Product hierarchy no. *			Part no.	SBU	Type / Description	Customer part no.
SBU	PG	PGU	Type			
01	001	007	0000000032	See list below	Circuit Protection	SPT 6.3x32 10-32A

2 Type of change

SPT 6.3x32					
creation date	created by	release date	released by	notification no.	revision
11.2.2015	SHÖ	17.2.2015	SHÖ	xxx	1 von 1

List of part numbers affected						
0001.2534	0001.2535	0001.2536	0001.2537	0001.2538	0001.2539

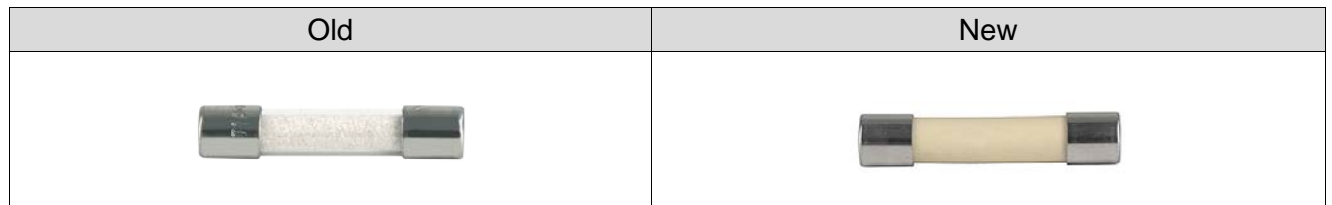
Material change. Soldering method change.

The tube material changed to ceramic.

Fuse element is now soldered internally to ferrules. Used to be soldered externally.

Form:	Yes	Tube material changed to ceramic
Fit:	No	No dimensional change
Function:	No	No functional change
Production Site:	No	Production site remains
